STANDARDS AUSTRALIA/STANDARDS NEW ZEALAND

Amendment No. 1
to
AS/NZS 1221:1997
Fire hose reels

REVISED TEXT

SUMMARY: This Amendment applies to clauses 2.3.1, 3.1, 4.3.1, 4.3.2, Table 2.1, Figure C1 and Appendix F.

FIGURE C1 DETAILS OF LOAD TEST FOR SWING ARM TYPE HOSE REELS

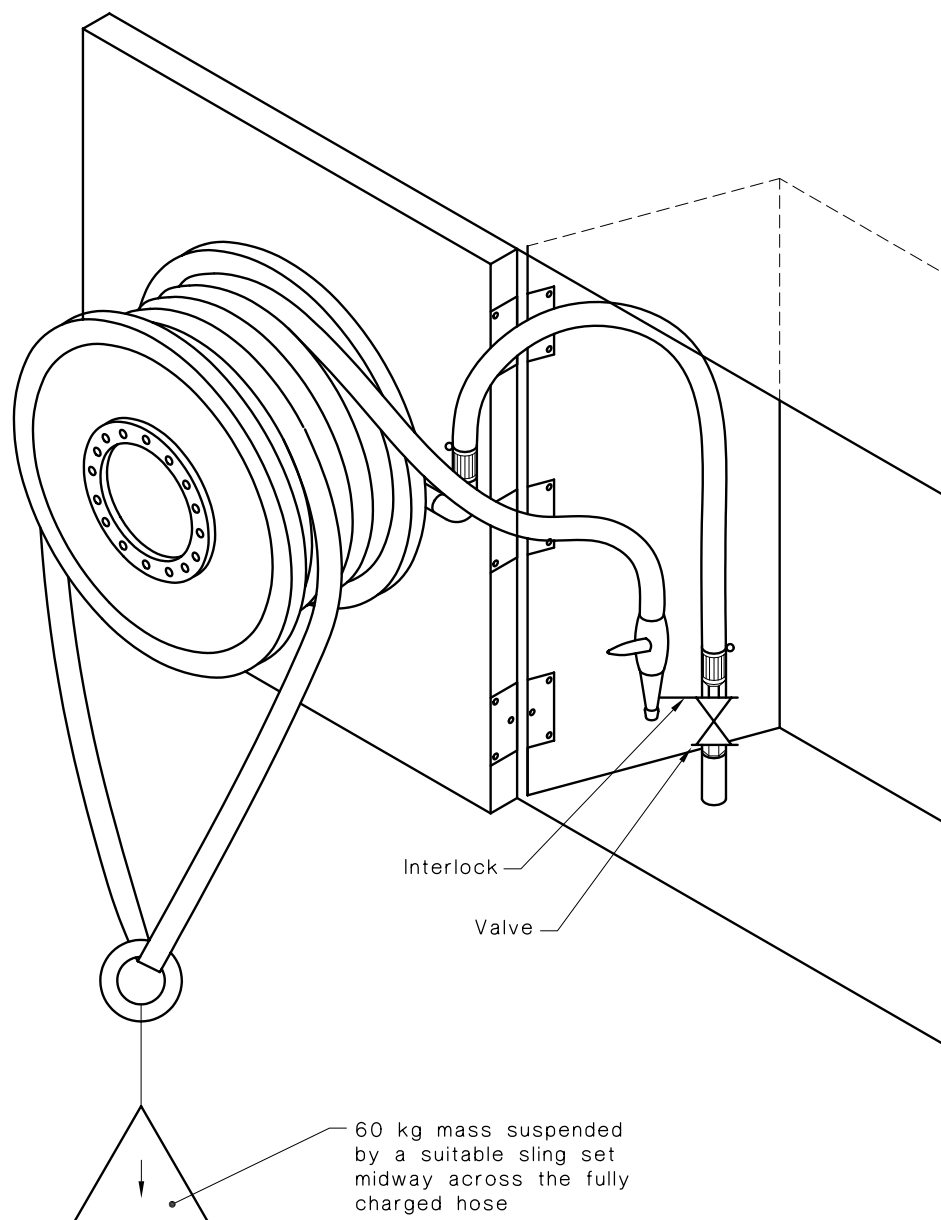
Page 24 Figure C1

Delete existing figure and replace with the following (In the caption for the weight the word 'changed' has been corrected to read 'charged'):
